V2500-A5 SERIES PROPULSION SYSTEM SERVICE BULLETIN

V2500-ENG-72-0152
Transmittal - Page 1 of 2

ENGINE – LP COMPRESSOR – REPLACE THE PTO DRIVE BEARING SUPPORT SHAFT SEALING RING**1. Planning Information****A. Effectivity**

Replacement of the Sealing Ring
Figure 1

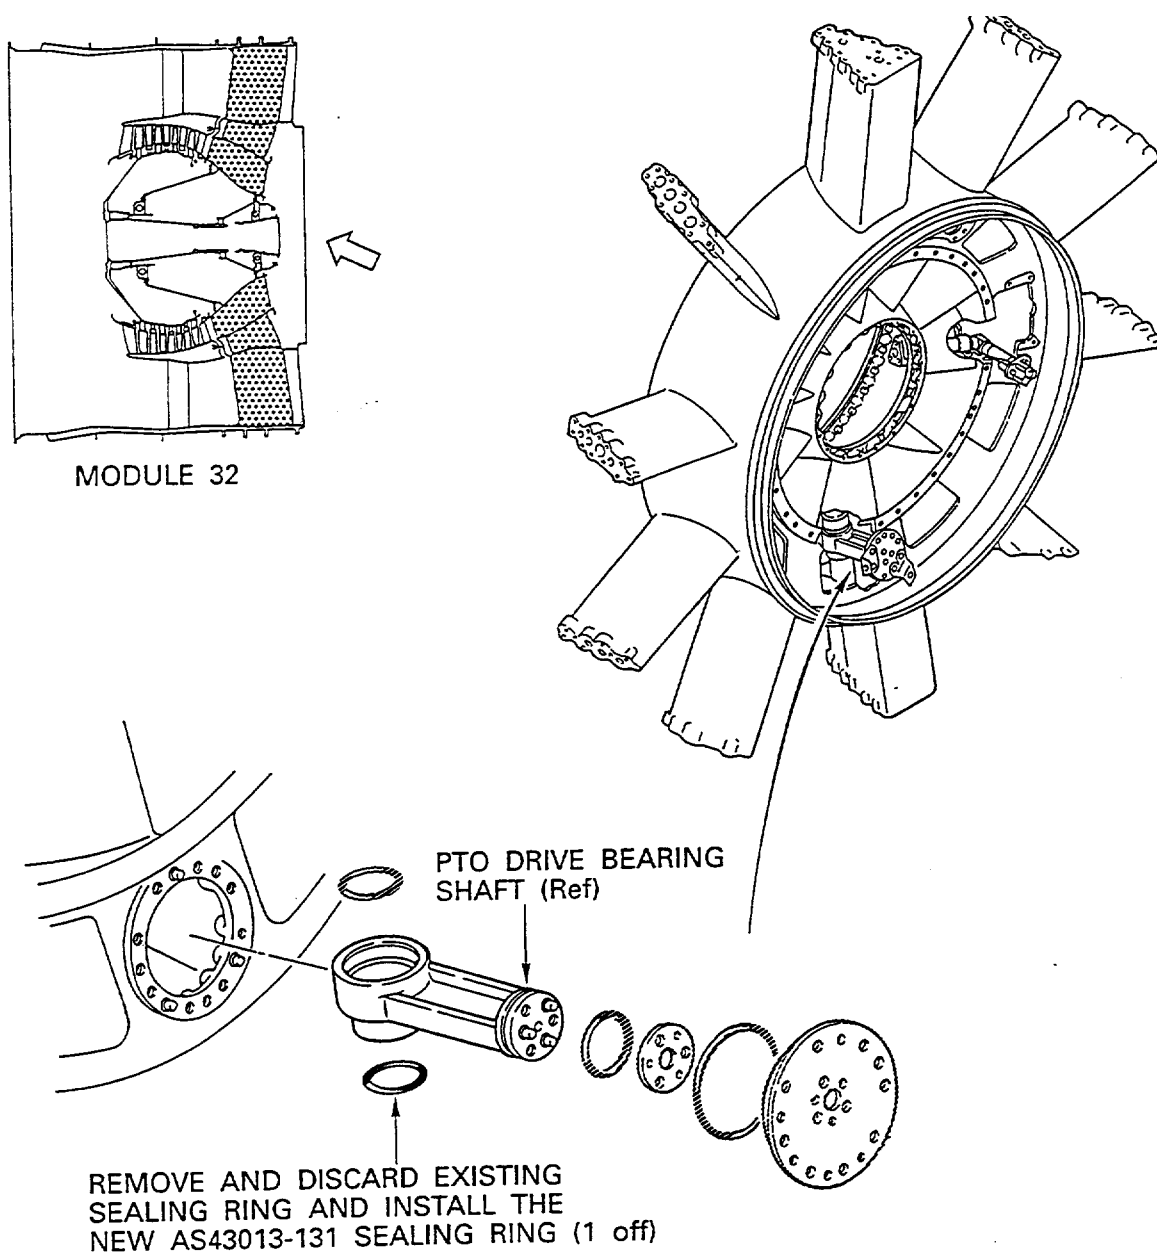
When the oil seal tube is installed into Fan Case Assembly, the existing sealing ring may cause twist in the housing A/O centre bearing.

To introduce new sealing ring into the centre bearing housing A/O.

- (1) The new sealing ring is introduced at centre bearing housing A/0.

NOTE: The existing sealing ring inside diameter is 1.598 to 1.628in. (40,56 to 41,33 mm) and new sealing ring inside diameter is 1.660 to 1.690in. (42,14 to 42,90 mm).

- (1) Remove and discard the existing sealing ring from the groove in the centre bearing housing assembly by approved procedures in Reference (2), Chapter/Section 72-32-00, Disassembly-14 (Refer to Figure 1).
- (2) Install the new AS43013-131, sealing ring into the groove in the centre bearing housing assembly by approved procedures in Reference (2), Chapter/Section 72-32-00, Assembly-02 (Refer to Figure 1).
